# Mt Keith Power Station Capacity Expansion Project

TEC Desert Pty Ltd and TEC Desert No.2 Pty Ltd in partnership as  
Southern Cross Energy

Report 1780

April 2025

**Figure 3: Annual emissions with proposed reduction targets**

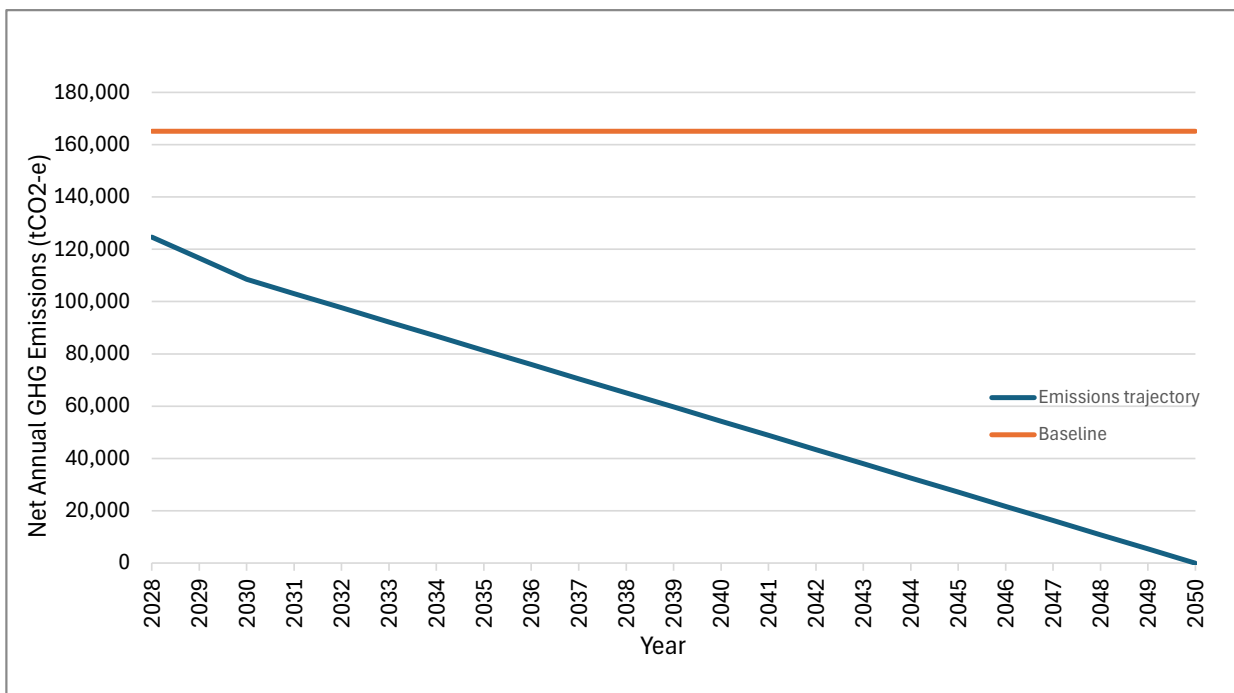
<p><b>Emissions trajectory to 2050</b></p>	
<p>The proponent has proposed a linear trajectory of emission reductions to net zero by 2050 for the proposal as shown in Figure 3, which factors in emission reductions to the baseline emissions from when operations are expected to commence in 2028.</p> <p>Separate to this proposal, but part of the proponent's regional decarbonisation strategy for the SCEN network, the proponent has recently developed the Northern Goldfields Solar Project comprising two solar farms and a BESS which connects to the SCEN network. In the medium to long term, the proponent proposes to displace older, less efficient legacy gas and diesel power on the SCEN network with additional renewable energy power sources (wind turbines, future solar and BESS) to support TransAlta's decarbonisation targets and achieve emissions reductions required</p>	<p>The EPA notes the proposed emissions reduction trajectory will mitigate approximately 2,400,334 t CO<sub>2</sub>-e of scope 1 emissions. The EPA considers these reductions are reasonably achievable through the adoption of emerging and new technology and major projects, and the use of offsets at other times.</p> <p>The EPA recognises that the Commonwealth Safeguard Mechanism requires the proponent to take actions to reduce scope 1 GHG emissions through decline rates to achieve net zero emissions by 2050, discussed further below.</p> <p>Overall, with regulation under the Safeguard Mechanism and emissions reductions proposed, the proposal is estimated to emit 1,380,406 t CO<sub>2</sub>-e of scope 1 emissions by 2050.</p>
